DEVELOPMENT APPLICATION REPORT APPROVALS REGISTER REPORT

DA NO: 5.2024.200.1

Development: Two (2) residential flat buildings, comprising fifty (50) build-to-rent dwellings with 20% allocation of dwellings being allocated as affordable rental housing; carparking; landscaping; and public domain works

Premises: LOT: 21 DP: 1124244, DP 365665 lot 3, DP 365665 lot 4, 138 Military Road EAST LISMORE, 144 Military Road EAST LISMORE, 146 Military Road EAST LISMORE

Figure 2. Location of protective fencing.

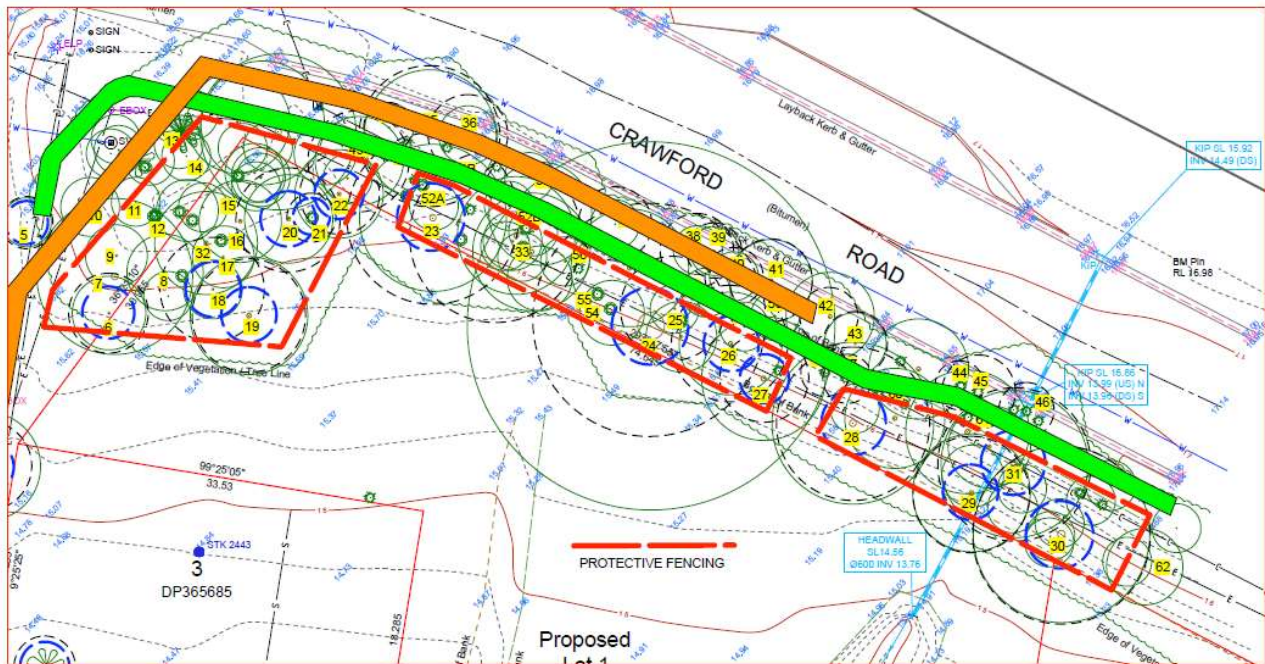
Direct impact includes clearing of planted understorey shrubs (24) and canopy trees (11) to accommodate pedestrian access and stormwater infrastructure works along Crawford Road

Figure 3 – Proposed roadworks (CI24/302272)

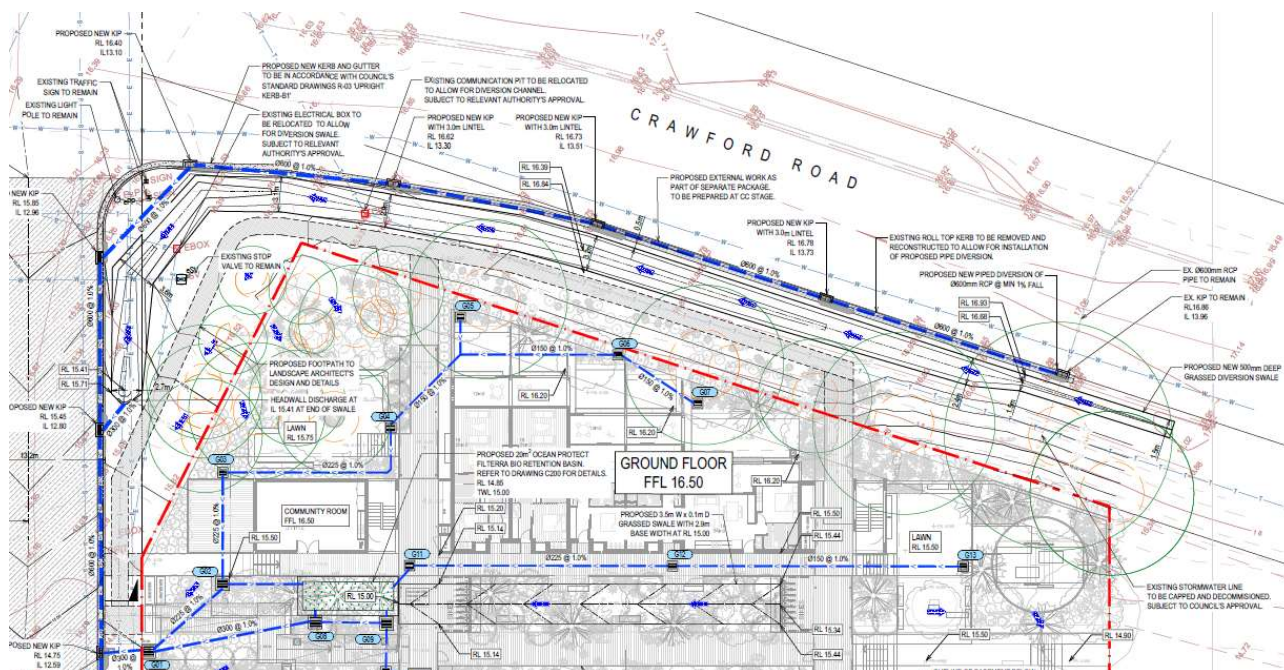
As the proposed development is within the Wilsons River Rous drinking water catchment, a 'NorBE' (neutral or beneficial effect) was required in line with Engineering Design Guideline D5 – Stormwater Drainage Design. The stormwater quality objectives have been shown to be achievable through the inclusion of a Filterra bio-retention basin, as demonstrated in Figures 4, 5, and 6 of the Civil Engineering Design Report (CI24/30221) and the MUSIC model results in the Stormwater Diversion Report (CI24/30222)

A 10,000-litre water tank is proposed as on-site detention to capture runoff from the site during minor storm events (10% AEP). Rather than increasing on-site detention for major storm events (1% AEP), the development will perform works on behalf of the council along Crawford Road to ensure the road network can handle and retain all runoff from both the development and upstream areas during major events. These works include the installation of an underground pipe system and a drainage swale on the southern side of Crawford Road to intercept stormwater runoff from East Lismore Cemetery, which currently drains onto the site through a 600mm diameter RCP beneath Crawford Road. TUFLOW modelling confirms that the proposed works will effectively divert stormwater to Military Road, which appears to be a suitable solution.

Figure 3 illustrates the proposed works, while Figure 4 shows the TUFLOW modelling results.

A condition requiring Stormwater drainage details to be submitted to council as part of Section 138 and Section 68 approvals prior to issue a Construction Certificate has been added.
